BUREAU OF LAND MANAGEMENT
Alaska State Office
222 West Seventh Avenue, #13
Anchorage, Alaska 99513-7504
www.blm.gov/alaska

1.0 Errata

The Willow Master Development Plan (MDP) Final Environmental Impact Statement (EIS) was published on August 14, 2020. This Errata sheet provides a list of corrected errors in the Final EIS.

1.1 Appendix D.2, Willow Mine Site Mining and Reclamation Plan

Figure 2.5.2

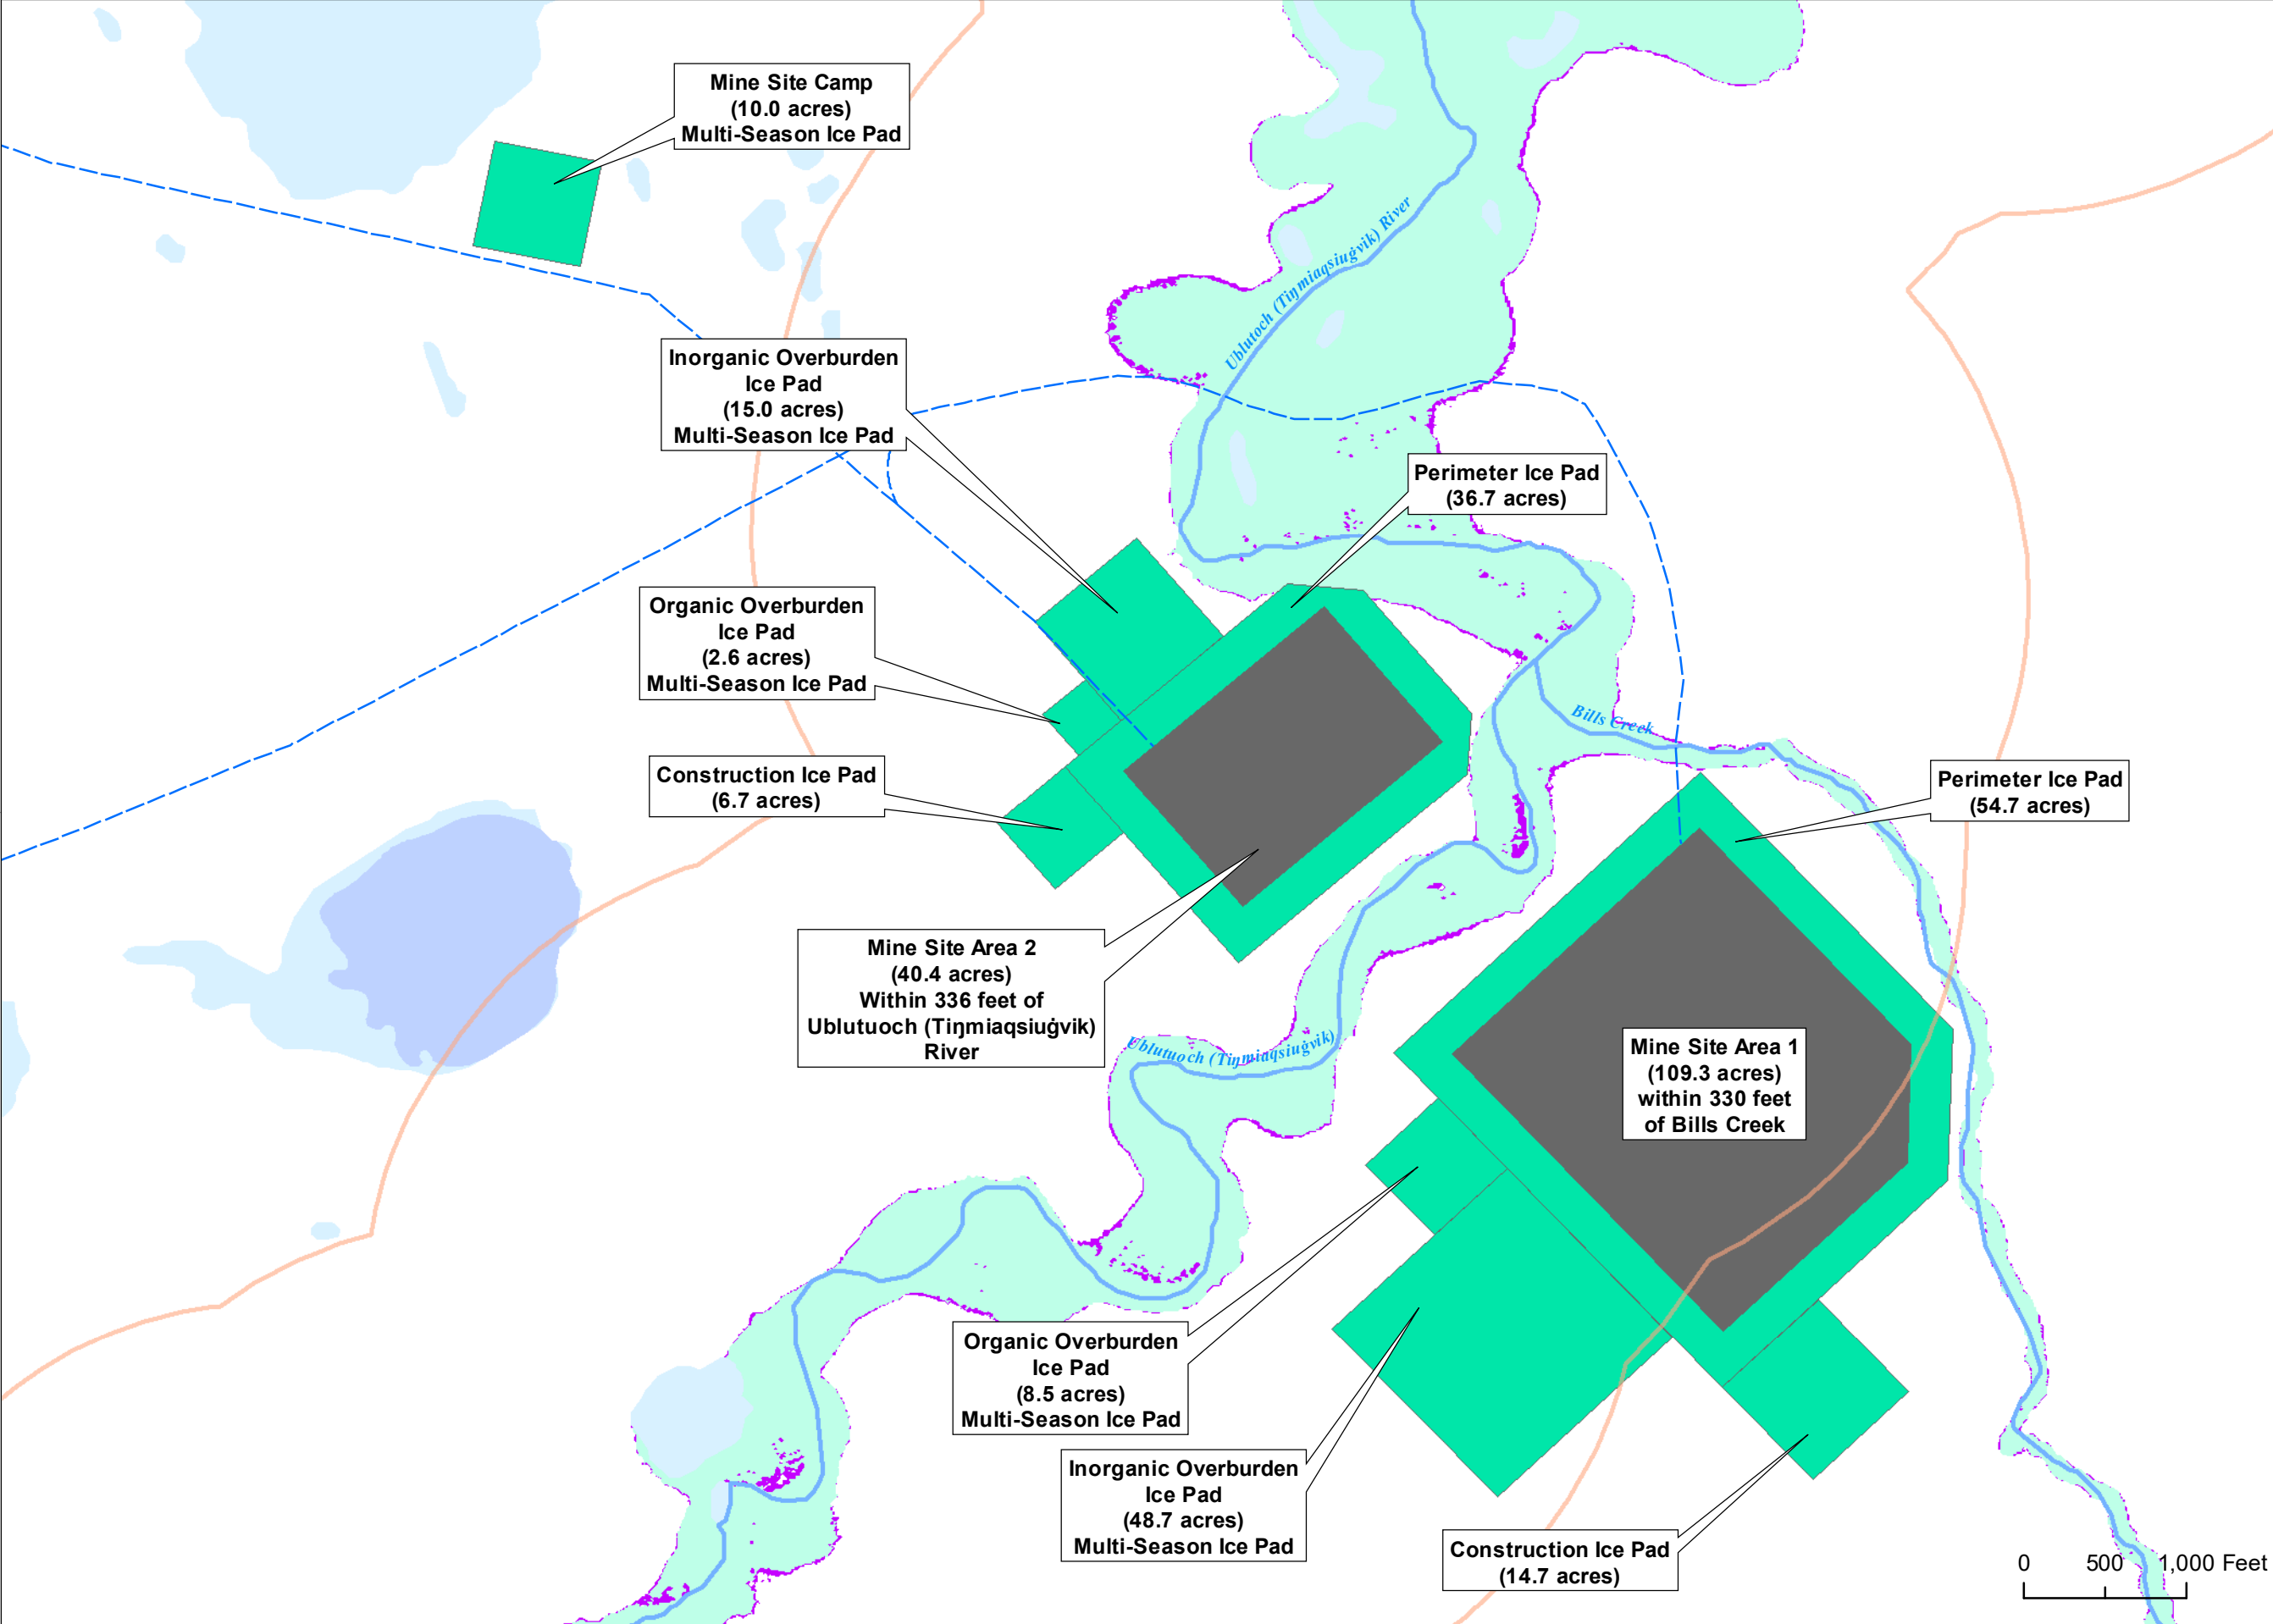
The Final EIS stated that there would be a total of 30 acres of multi-season ice pads at the Tiñmiaqsiuǵvik Gravel Mine Site for each action alternative. This should be corrected to be 84.8 acres of multi-season ice pads. The total area covered by ice pads (single-season combined with multi-season) was correct in the Final EIS; only the proportion of acres of multi-season versus single-season is corrected here. The Final EIS Figure 2.5.2 (Tiñmiaqsiuǵvik Gravel Mine Site) should show that the inorganic overburden ice pad and the organic overburden ice pad are multi-season ice pads at both mine site area 1 and mine site area 2 (a total of 4 ice pads). These were incorrectly described as single-season ice pads in the Final EIS. An updated figure is included with this Errata.

Mine Site Ice Infrastructure	Corrected Acres	Final EIS Acres
Single-Season Ice Pads	133.2	188.0
Multi-Season Ice Pads	84.8	30.0
Total Ice Pads	218.0	218.0
